PRE-FILED HEARING EXHIBIT LIST FOR KHOA HA RUE OPEN RECORD PUBLIC HEARING

**PLANNING DEPARTMENT**  
**STAFF REPORT**  
**TO CITY OF LAKE FOREST PARK HEARING EXAMINER**

**City File Numbers:** 2020-RUE-0002

**Requested Action:** Approval of reasonable economic use exception from critical area regulations, to construct one single family residence. The proposal also includes construction of utility and access improvements, as well as installation of critical area mitigation.

**Exhibit 5.0**

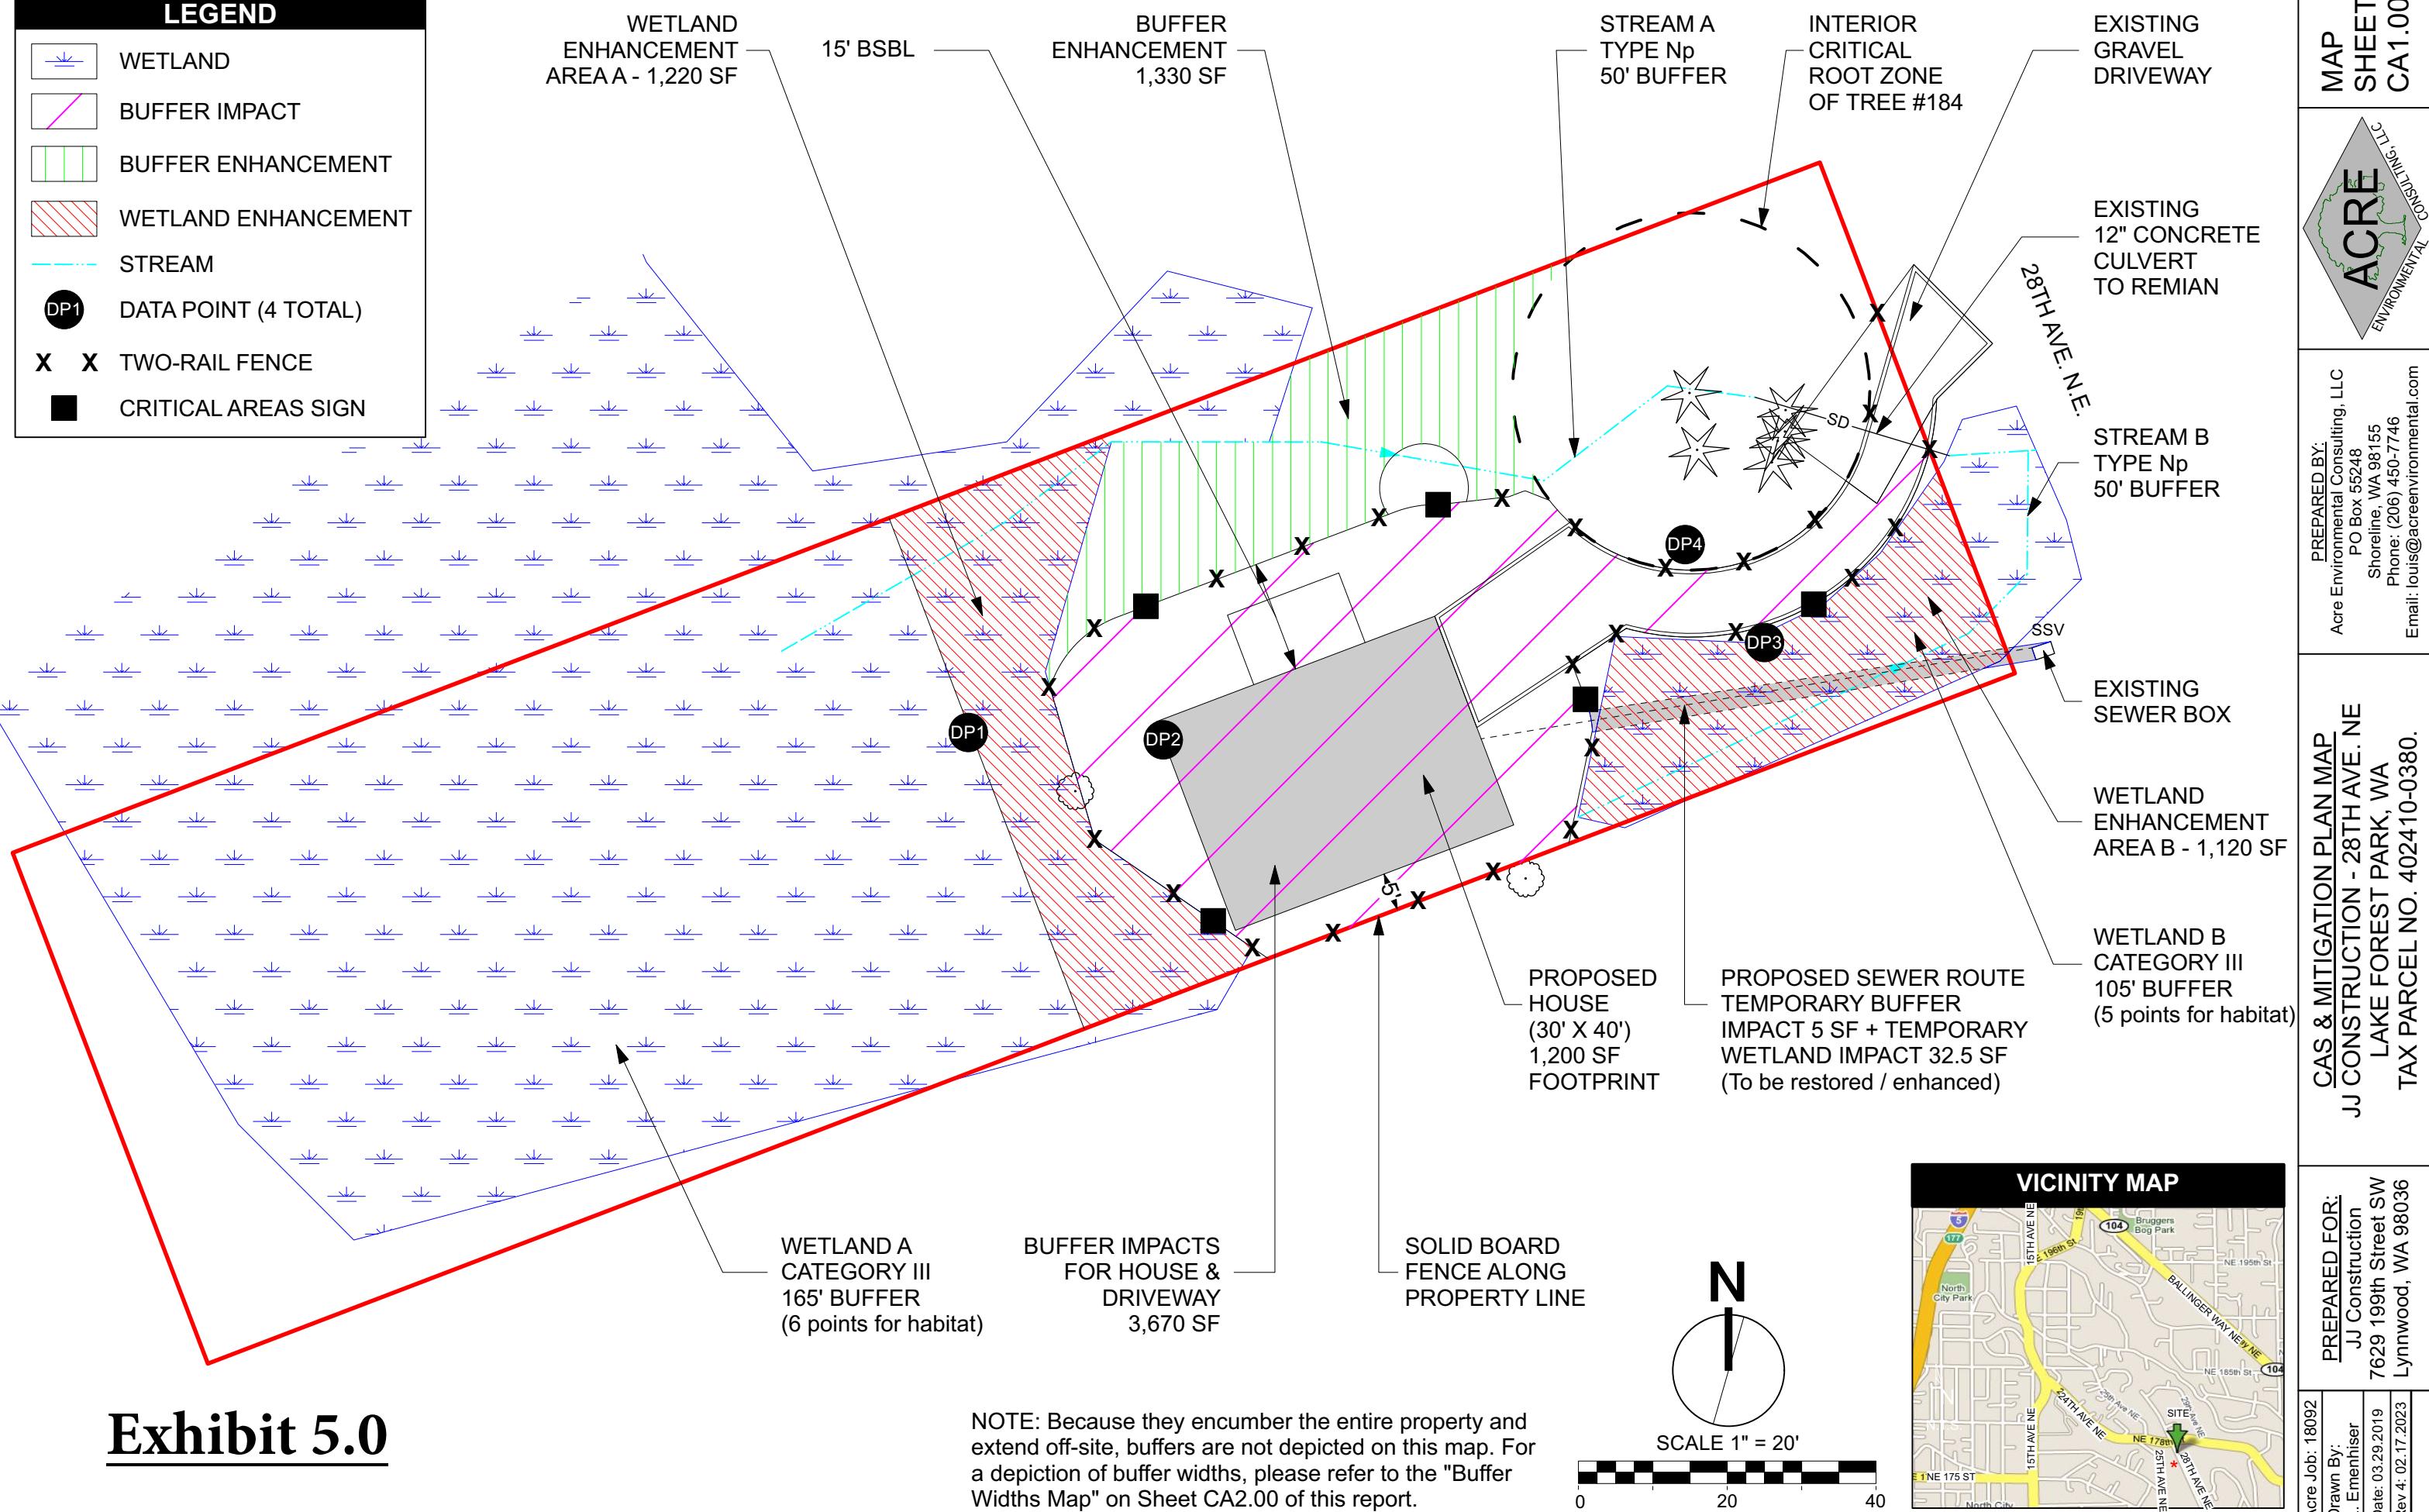
This is in conflict with the recommendations of the Critical Areas report, and the site plan, which shows two infiltration areas on either side of the drive, and directs southern infiltration directly into wetland B.

The general "Site plan" indicates several "trees to be protected" yet simultaneously shows the driveway overrunning the stand of cedars just to the north of it. In the case of tree 22, the driveway appears to run right through it. The Planning Director has previously determined in similar development proposals that such general site plan does not meet the requirement for identification and location of significant trees. There is an arborist report included in the application, but it is very explicit that the evaluation was limited in scope and funding. The report states that the arborist was asked to evaluate eight specific trees.

The current plan clearly does not protect the critical root zone of significant trees, as confirmed by the arborist's letter, which simply states that trees 4-8 will not survive. The largest evaluated cedar tree (#3) is not specifically addressed, nor does it consider the effect of losing the closely associated trees in the stand (#4-8).

1. Exhibit 5 shall be the approved site plan for this Reasonable Use Exception. The construction impact zone shall be the area surrounded by the line labeled “two rail fence”, as well as that area delineated for the disturbance necessary to install the side sewer service.
